Submit 1 Copy To Appropriate District Office	State of New Mexico	Form C-103
District I - (575) 393-6161	Energy, Minerals and Natural Resources	Revised July 18, 2013
1625 N. French Dr., Hobbs, NM 88240 District II – (575) 748-1283		WELL API NO. 30-025-03459
811 S. First St., Artesia, NM 88210	OIL CONSERVATION DIVISION	5. Indicate Type of Lease
<u>District III</u> – (505) 334-6178 1000 Rio Brazos Rd., Aztec, NM 87410	1220 South St. Francis Dr.	STATE X FEE
District IV - (505) 476-3460	Santa Fe, NM 87505	6. State Oil & Gas Lease No.
1220 S. St. Francis Dr., Santa Fe, NM 87505		E-444
	ES AND REPORTS ON WELLS	7. Lease Name or Unit Agreement Name
(DO NOT USE THIS FORM FOR PROPOSAL	LS TO DRILL OR TO DEEPEN OR PLUG BACK TO A	
DIFFERENT RESERVOIR, USE "APPLICA" PROPOSALS.)	FION FOR PERMIT" (FORM C-101) FOR SUCH	
	as Well X Other	8. Well Number 1

2. Name of Operator		9. OGRID Number
MOMENTUM OPERATING CO., J	NC.	196069 10. Pool name or Wildcat
3. Address of Operator P.O. BOX 2439, ALBANY, TEXAS	76430	EUMONT YATES SEVEN RIVERS

Operator:	OGRID:
MOMENTUM OPERATING CO INC	196069
P. O. Box 2439	Action Number:
Albany, TX 76430	224327
	Action Type:
	[C-103] NOI Plug & Abandon (C-103F)

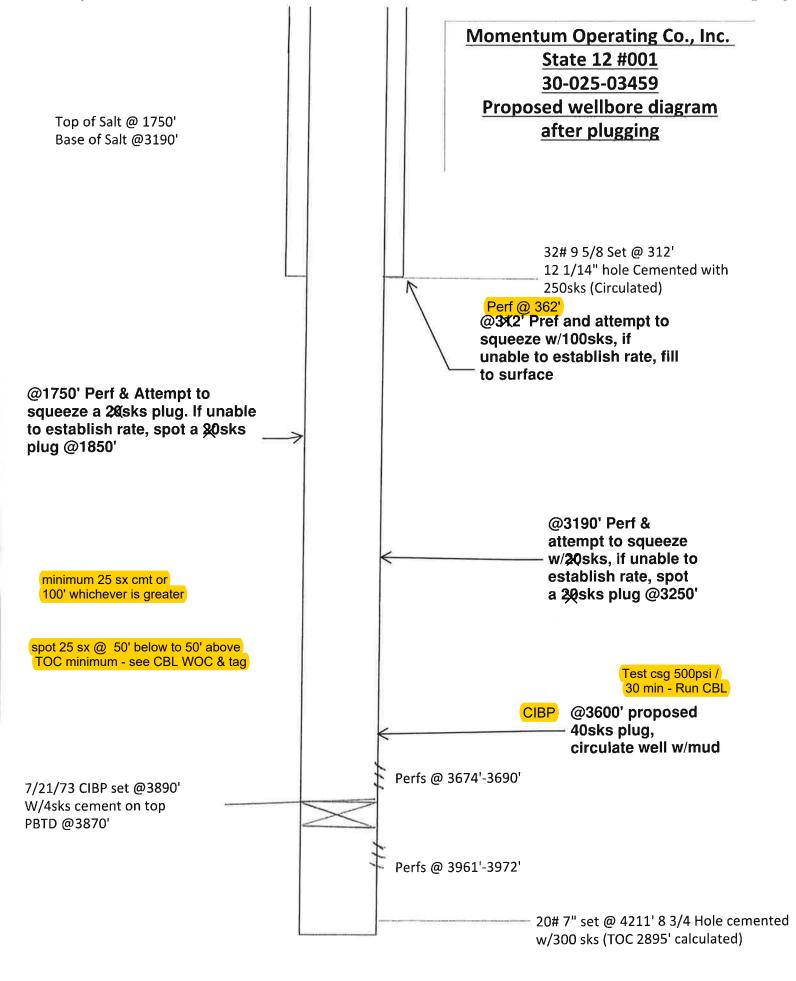
13. Describe proposed or complete of starting any proposed work proposed completion or recom 1. Stot a Msks plug 3600'. Cir 2. Perf and attempt to squeeze	ed operations. (Clearly state all pertinent details, and). SEE RULE 19.15.7.14 NMAC. For Multiple Copletion. Ru Coulate well with mud Set CIBP @ 3600' - test @3190' with Makes plug. If unable to establish spot	mpletions: Attach wellbore diagram of n CBL to surface. casing 500psi/30min. Spot 25 sx cmt on pluga 25ks plug @3250.

13. Describe proposed or complete of starting any proposed work proposed completion or recommendate. 1. Sept. a Mesks plug 3600'. Cit. 2. Perf and attempt to squeeze 3. Perf and attempt to squeeze 4. Perf and attempt to squeeze Perf. spot 25 sx.	ed operations. (Clearly state all pertinent details, and). SEE RULE 19.15.7.14 NMAC. For Multiple Copletion. Ru Culate well with mud Set CIBP @ 3600' - test @ 3190' with Xsks plug. If unable to establish spot at 1750' with a Xsks plug. If unable to establish rate at 32' with 100sks plug. If unable to establish rate, @ 362' @ 50' below to 50' above TOC minimum - see	mpletions: Attach wellbore diagram of n CBL to surface. casing 500psi/30min. Spot 25 sx cmt on plug a %sks plug @3250. e, spot a Msks plug @ 1850' fill to surface. CBL WOC & tag

13. Describe proposed or complete of starting any proposed work proposed completion or recomplete of starting any proposed work proposed completion or recomplete of the starting and proposed completion or recomplete of the starting and sta	ed operations. (Clearly state all pertinent details, and). SEE RULE 19.15.7.14 NMAC. For Multiple Copletion. Rusculate well with mud Set CIBP @ 3600' - test @ 3190' with % sks plug. If unable to establish spot at 1750' with a % sks plug. If unable to establish rate at 3×2' with 100sks plug. If unable to establish rate, @ 362' © 50' below to 50' above TOC minimum - see an 25 sx cmt or 100' whichever is greater Ction 10/1/2005 Rig Release Date:	mpletions: Attach wellbore diagram of n CBL to surface. casing 500psi/30min. Spot 25 sx cmt on plug a %sks plug @3250. e, spot a %sks plug @ 1850' fill to surface. CBL WOC & tag Verify cmt to surface on all strings
